RFI # 483
Date: 7/16/2008
Job: WA-011 Olive Way High-Rise
Phone:

Subject: Level 27 and 28 bonded tendons (BAK #142)

TENDON LAYOUT LEVEL 27

OLIVIAN TOWER

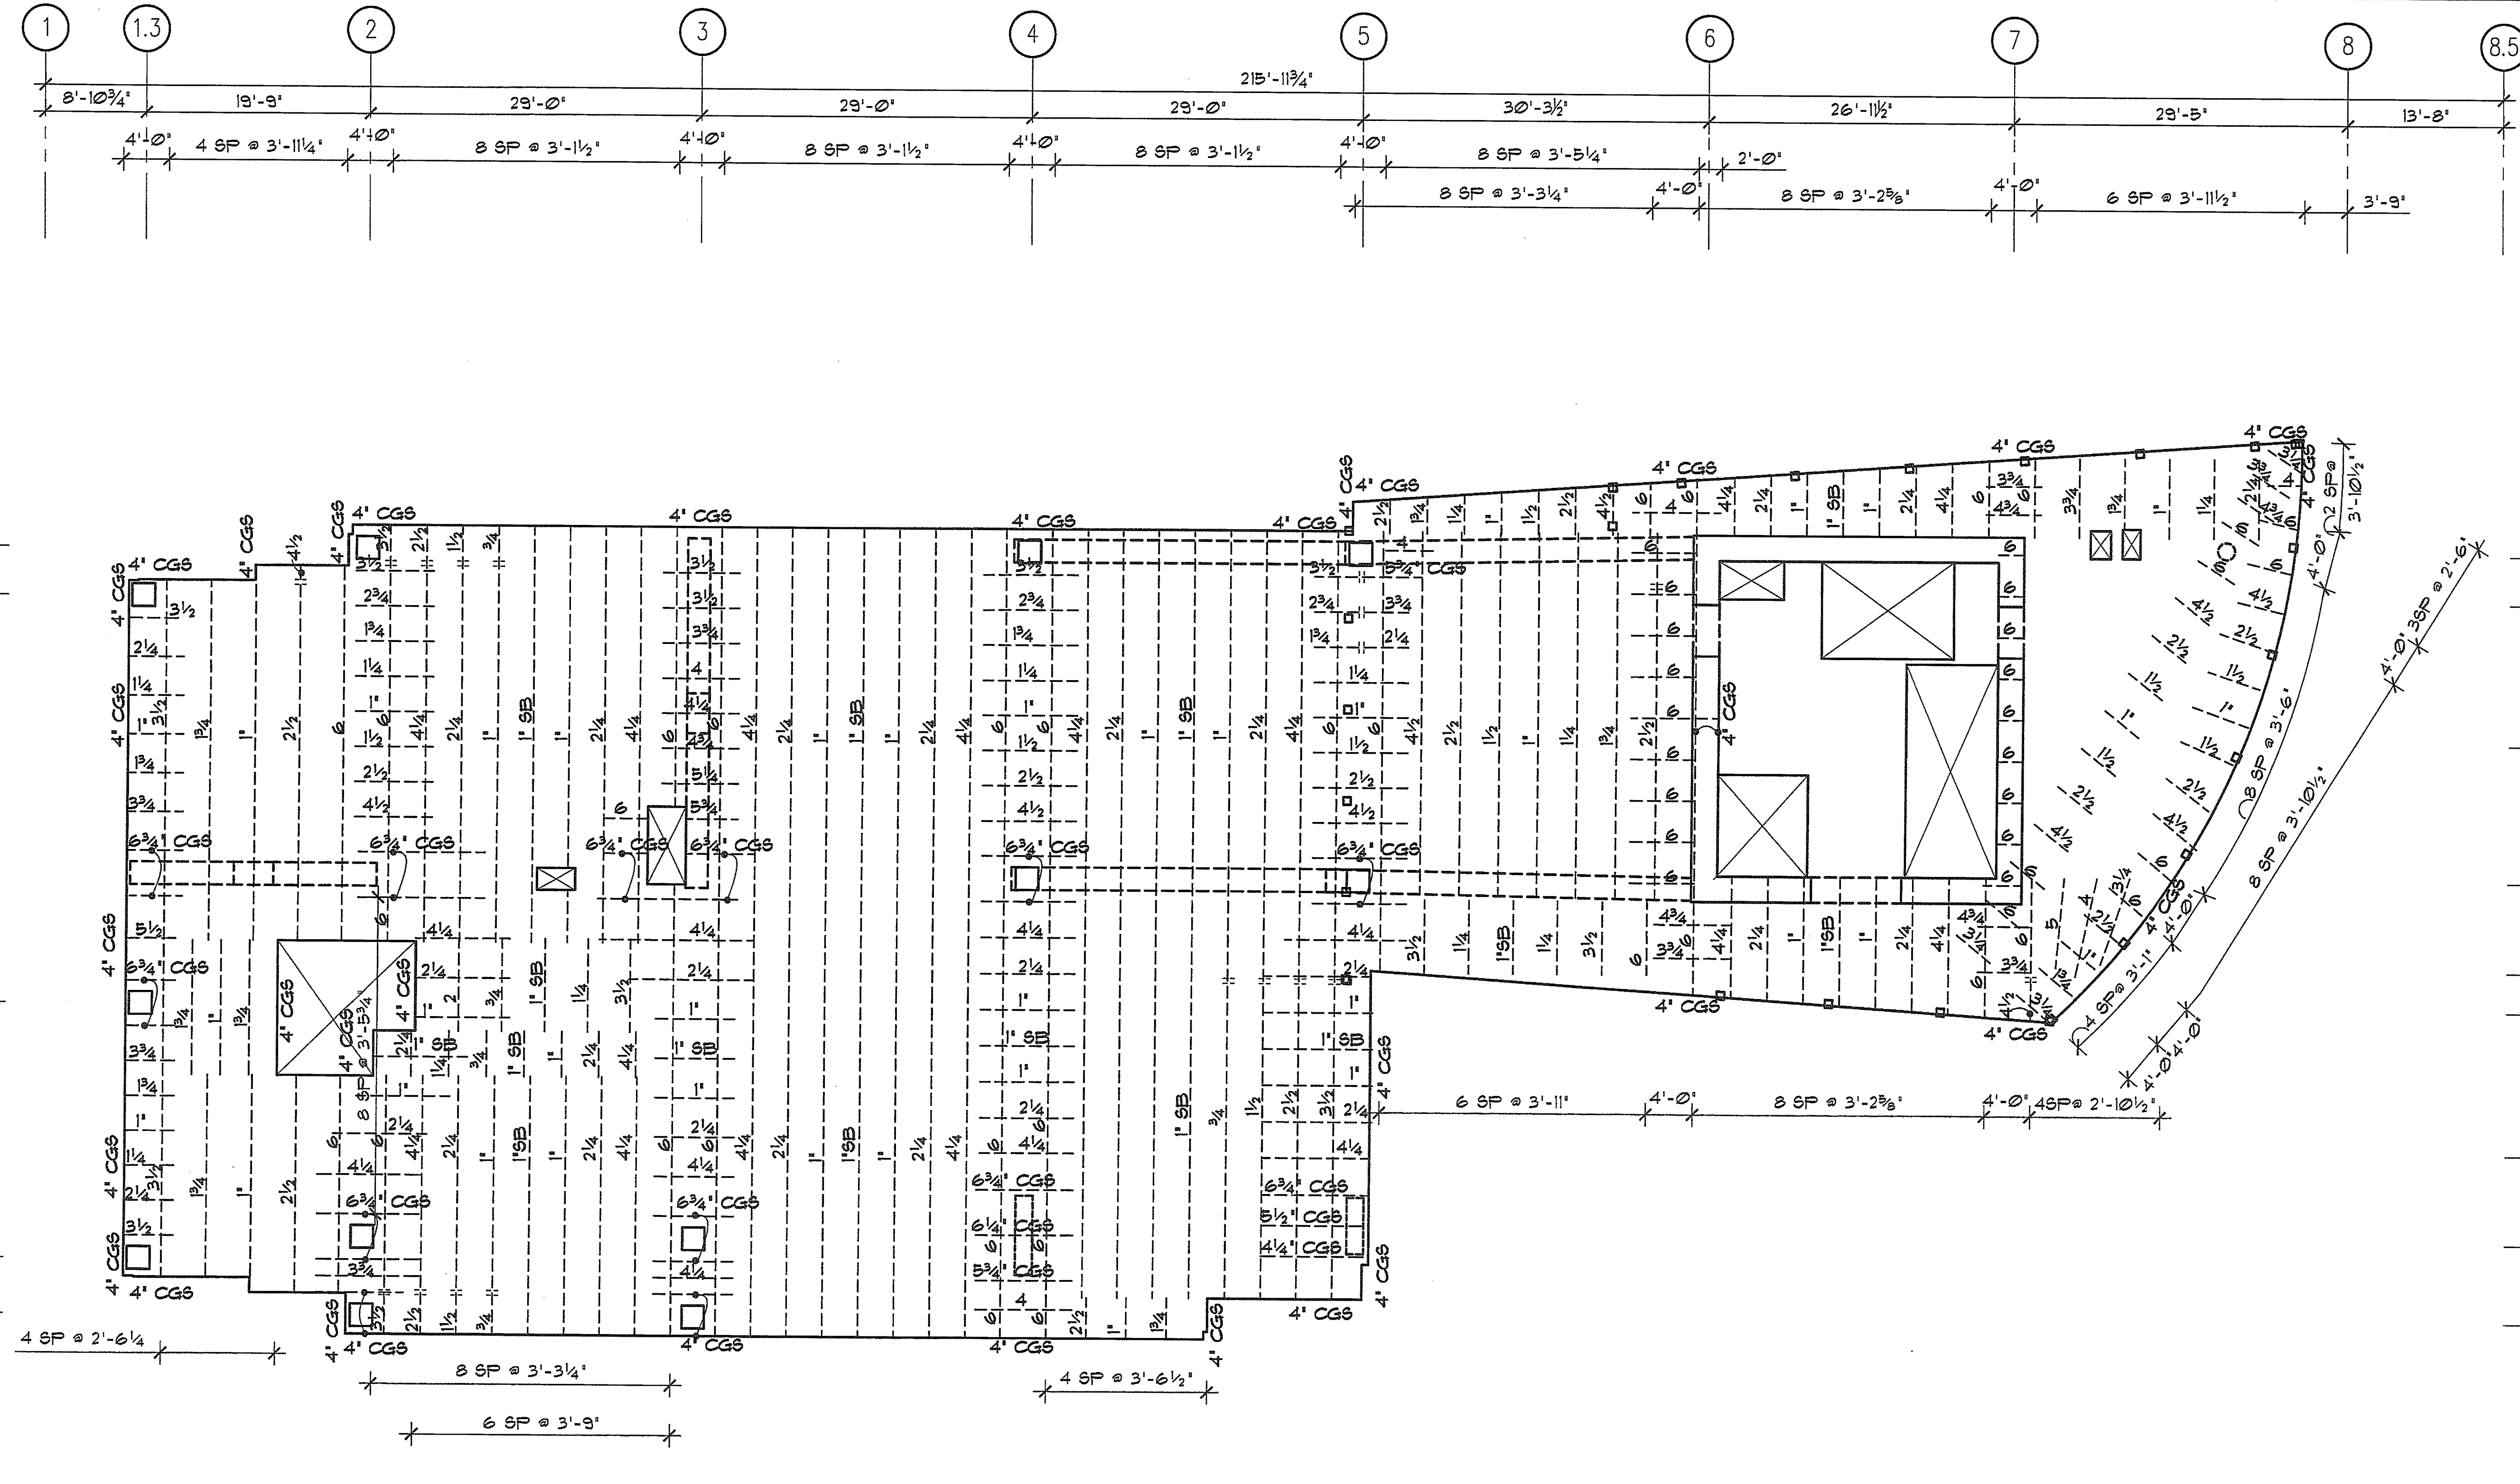
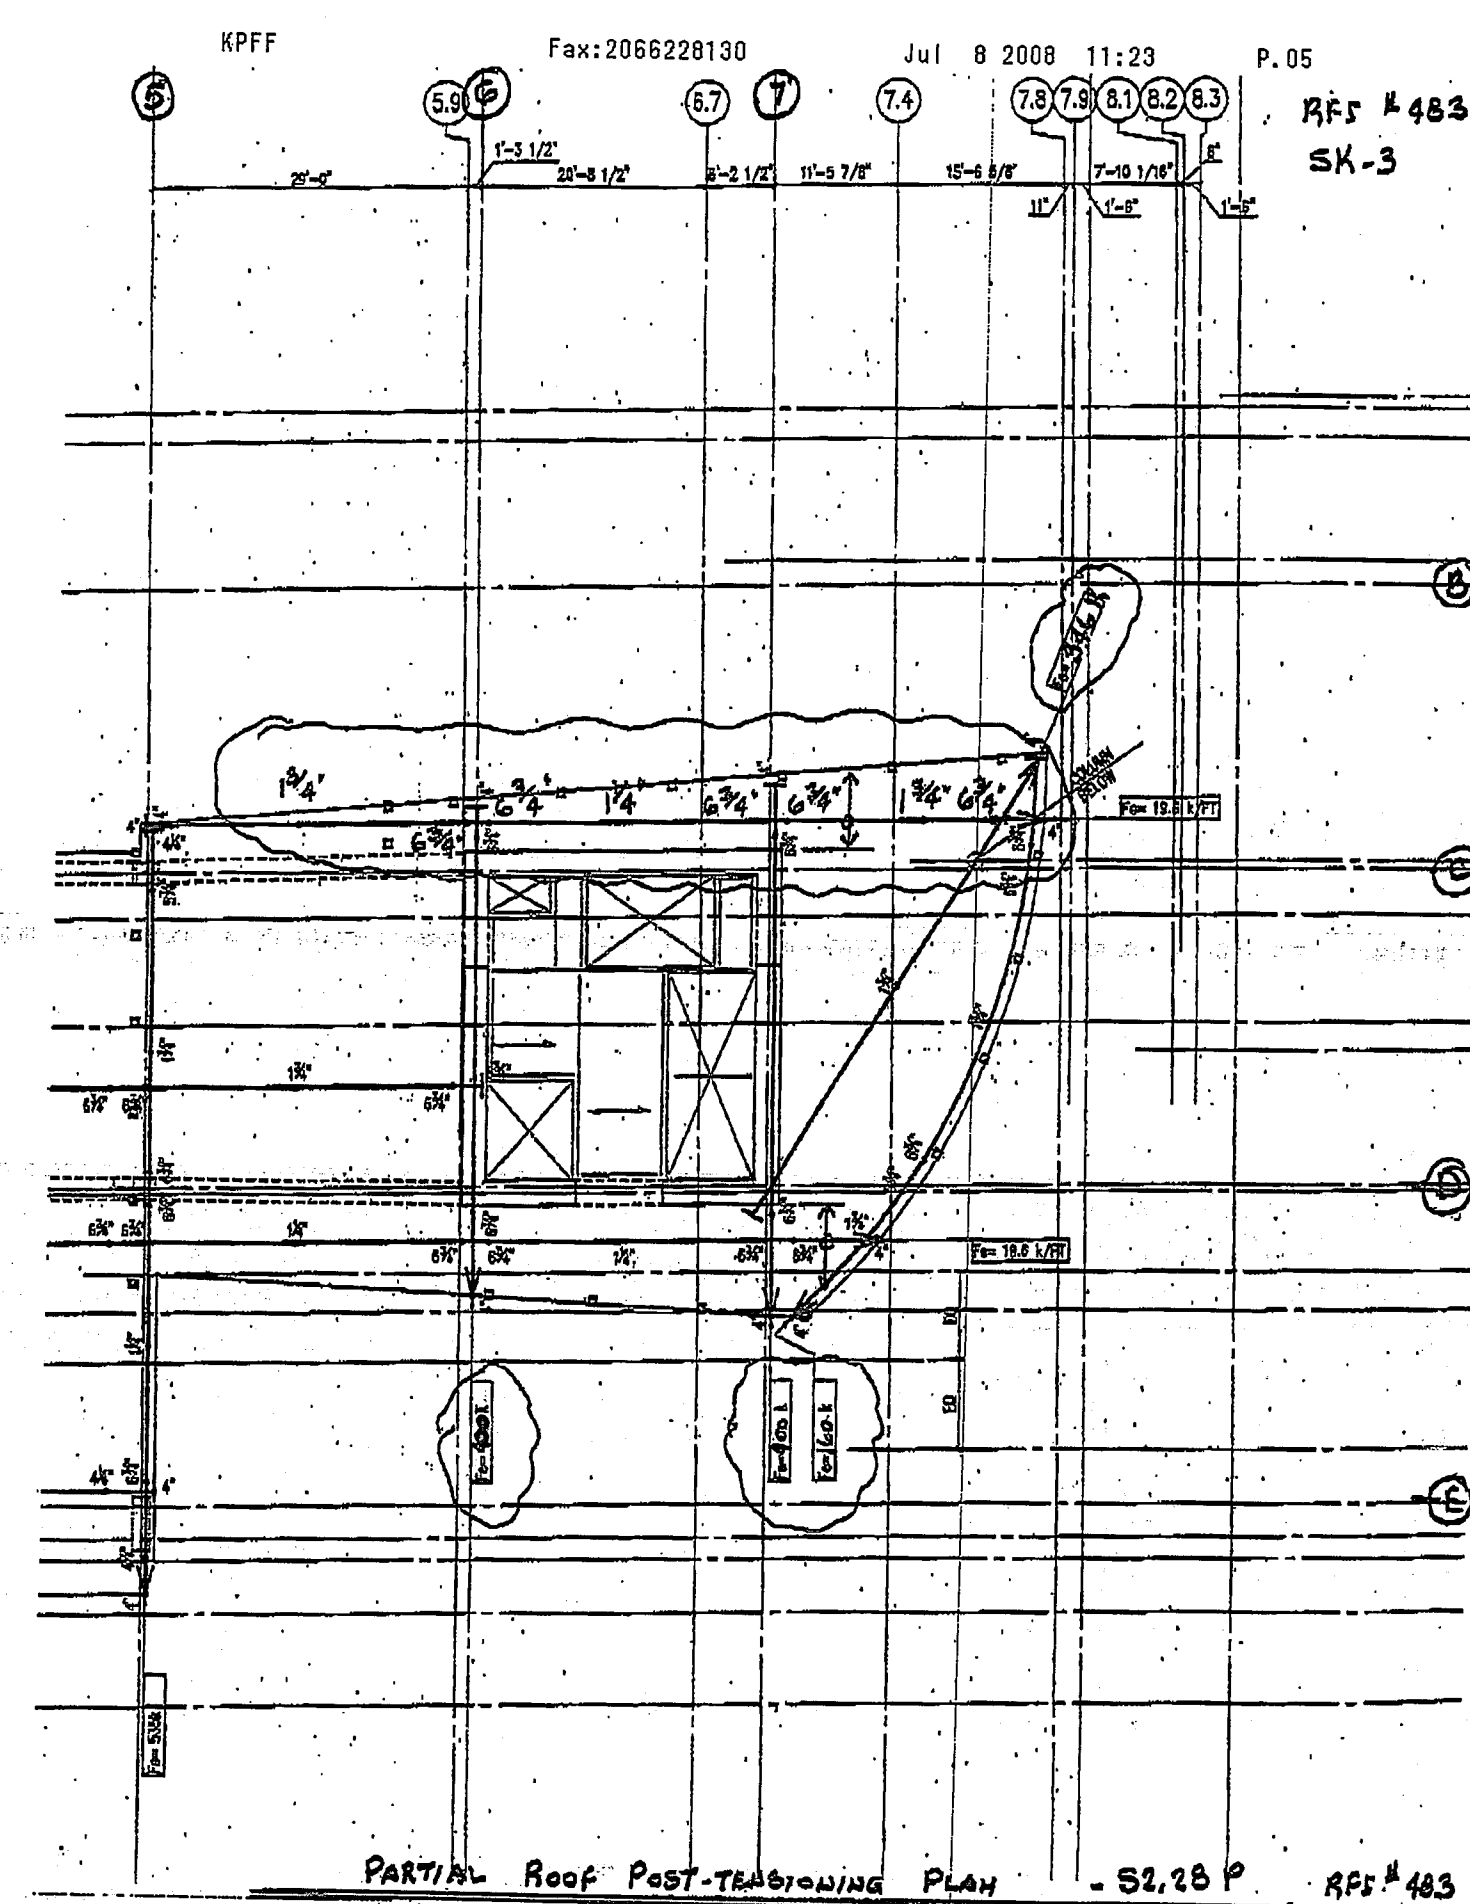
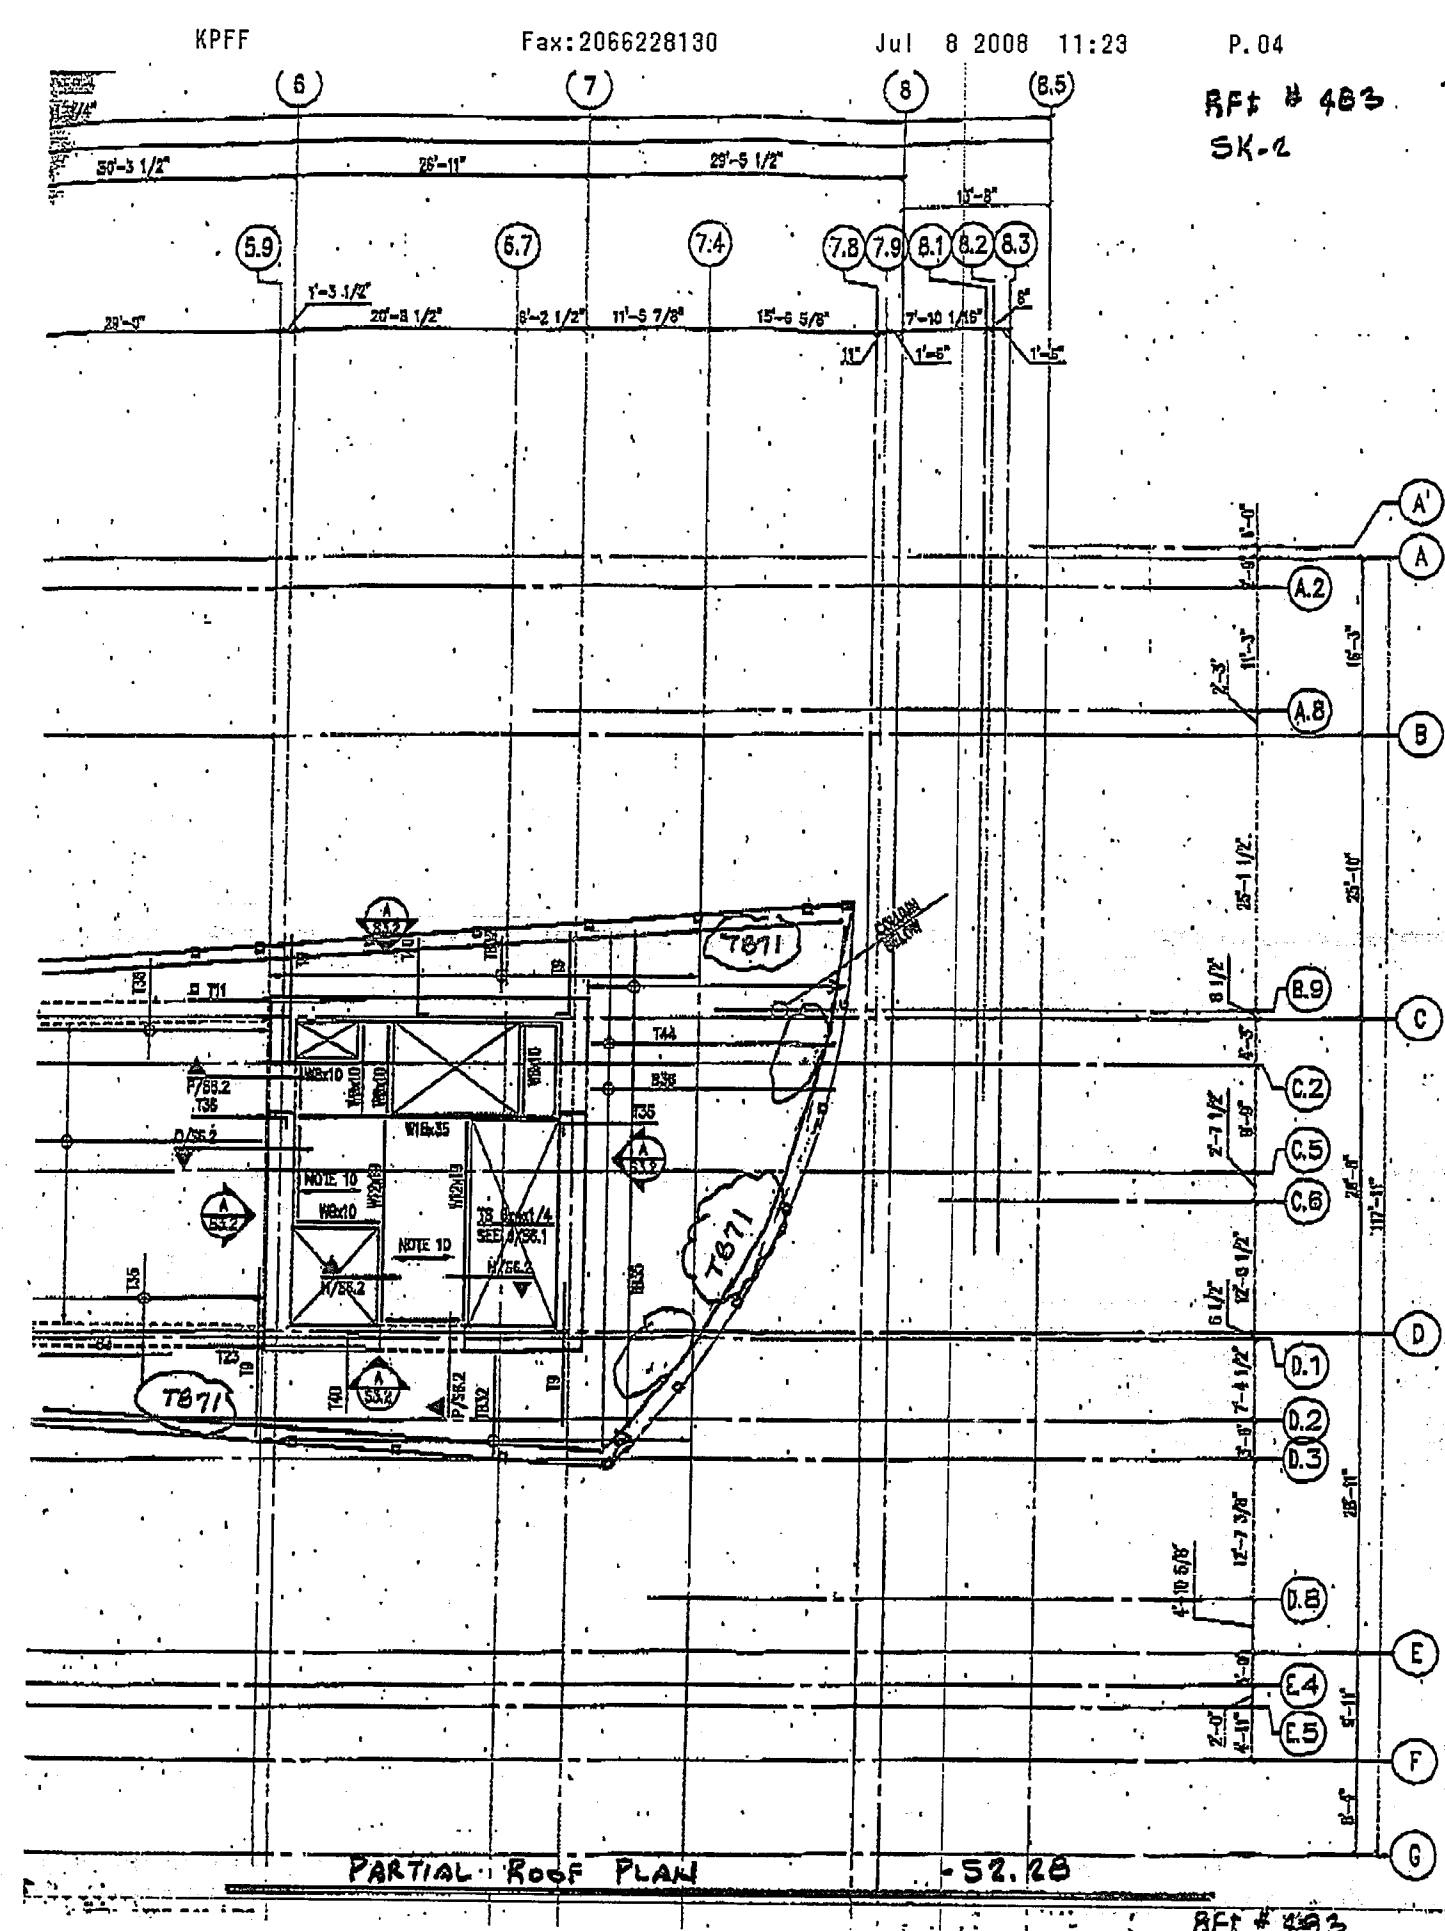
Request: Please provide the missing force information for level 27 at grid 6, 7 and 8, 10, and for level 28 at grid 6, 7, and 7.3. Please provide the missing profile information for levels 27 and 28 at 8.8.

Response: SEE ATTACHED SHEETS SK-1, 2 AND 3.
